Dunkin' Donuts & Baskin Robbins Facade SP 11-40A

FAÇADE REVIEW

Re: **FACADE ORDINANCE - Facade Ordinance Review**
 Project: **Dunkin Donuts & Baskin Robbins**
 SP Number: **SP11-40**
 Façade Region: 1, Zoning District: B-1

PROPOSED ELEVATION

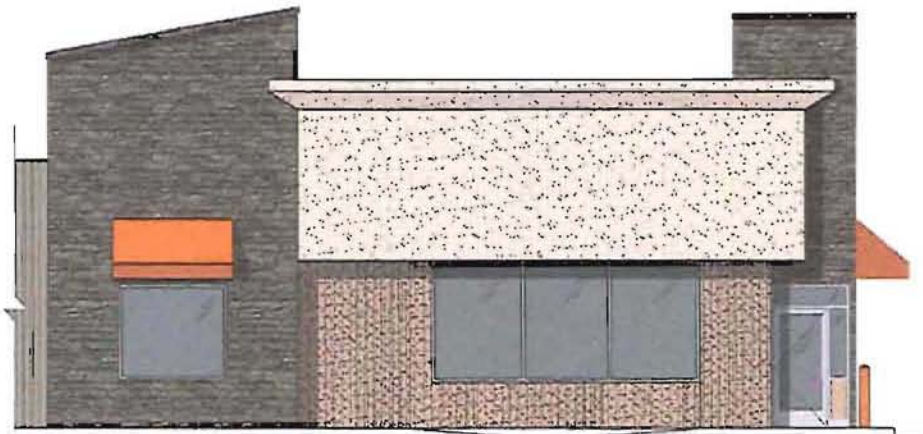
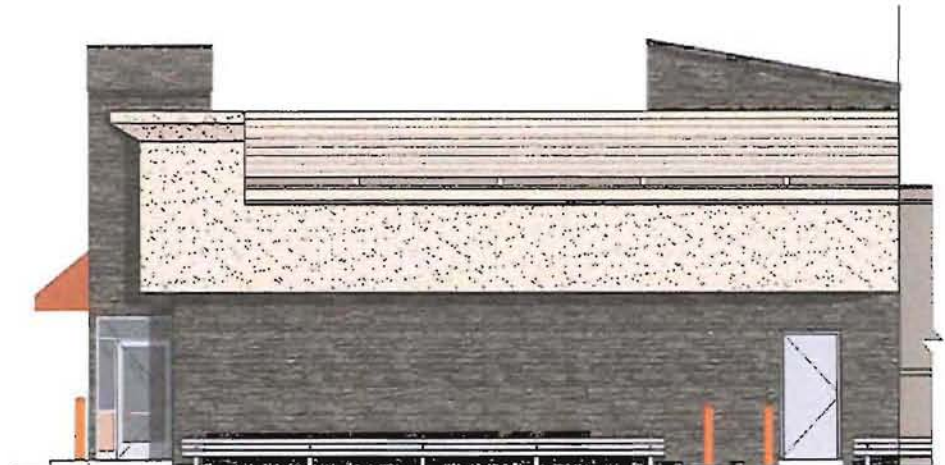
North (Front)	East (Left)	West (Right)	South (Unaltered)	Ordinance Maximum (Minimum)
Brick	0%	0%	0%	N/A	100% (30%)
EIFS	52%	39%	33%	N/A	25%
Fluted Block (existing)	23%	19%	0%	N/A	10%
Ribbed Metal Siding (screen)	0%	0%	17%	N/A	0%
Cultured Stone	23%	39%	50%	N/A	50%
Fabric Awning	2%	3%	0%	N/A	10%

Section 2520.6 of the Façade Ordinance requires that when new materials are proposed for an existing façade, the entire façade shall be brought into compliance, unless the altered area is visually separated by offsets or other features. In this case no such offsets exist. Therefore, strict interpretation of the Ordinance would require that the north, east and west facades be brought into full compliance with the Façade Ordinance. In this case practical difficulty of bringing the balance of the east façade into compliance is recognized given the fact these storefronts are occupied by other tenants.

As shown above the percentages of EIFS, fluted block, and ribbed metal exceed the maximum percentages allowed by the Ordinance and the percentage of Brick is below the minimum percentage required by the Ordinance.

The applicant has made significant revisions to the proposed design in response to comments provided in the first review. These include substituting cultured stone for wood siding, elimination of the corporate orange color from permanent façade elements (it remains only on the fabric awning), covering unsightly block and metal on the west façade with cultured stone and EIFS, and the addition of roof screens to conceal existing roof mounted equipment.

Recommendation – The revised façade exhibits a balanced composition of existing and proposed materials and will significantly enhance the overall appearance of the building. It is our recommendation that the design is consistent with the intent and purpose of the Façade Ordinance, and a Section 9 Waiver be granted for the underage of brick and the overage EIFS, ribbed metal and fluted block. The applicant should provide a revised color sample board showing the revised materials and colors.

1. Facade Material and Colors: The building materials and finishes as proposed and approved shall not be substituted without Planning Department approval. We will provide samples of the EIFS, Cultured Stone, and Paint Samples to Planning Department for Final Approval.
2. Exterior Signage: Exterior Signage shall be reviewed and approved under separate Sign Permit.
